Technical Service Bulletin

91 Sound system has background static with hill-hold active

91 13 12 2035013/1 October 31, 2013.

Model(s)	Year	VIN Range	Vehicle-Specific Equipment
A3	2010 - 2013	All	Not Applicable

Figure 1. Overlay cable routing through plenum (dotted line shows recommended routing).

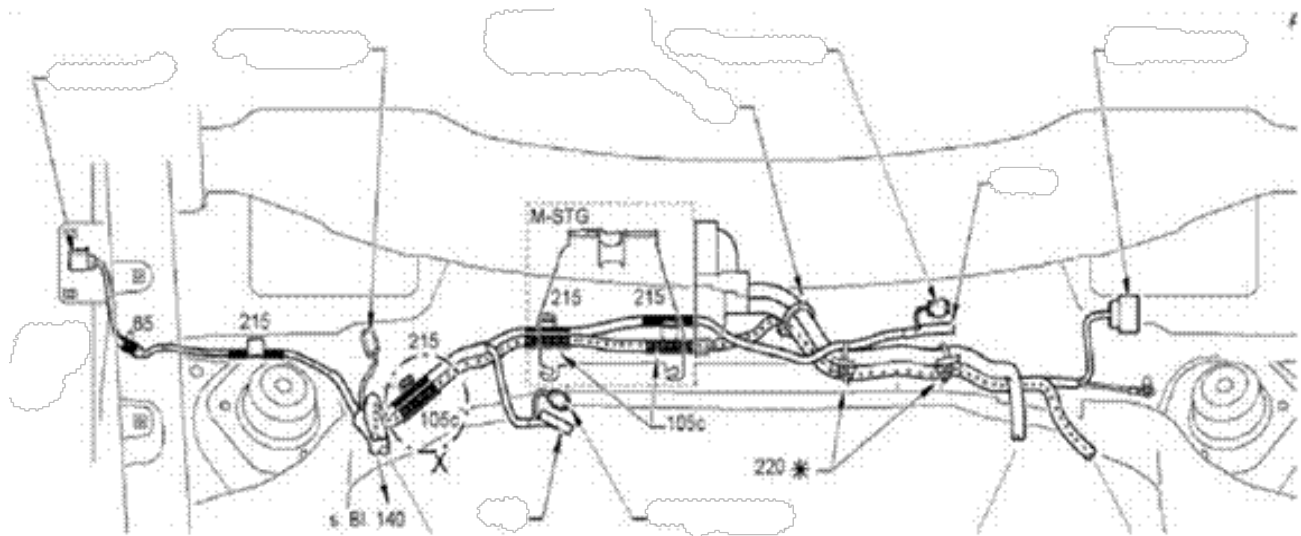
1. Remove battery, battery tray, Central Electrics, and cowl panel trim to perform overlay.
2. Using a 10AWG cable, overlay from pin 32 of the ESP to pin 27 in block T40 of the Central Electrics through plenum (Figure 1). Use corrugated pipe (part number: **N10732401**) to protect overlay.

Figure 7. Routing out of plenum chamber to ESP.

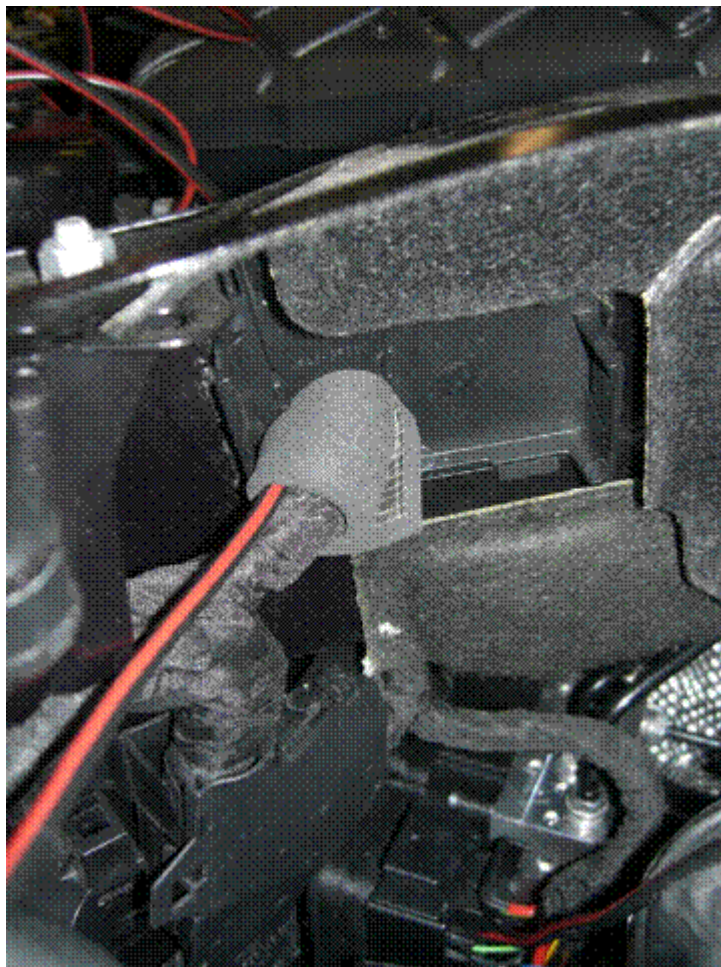
7. Return cable to engine compartment through plenum wall (Figure 7). Route to pin 32 of the ESP, affix terminal and secure.
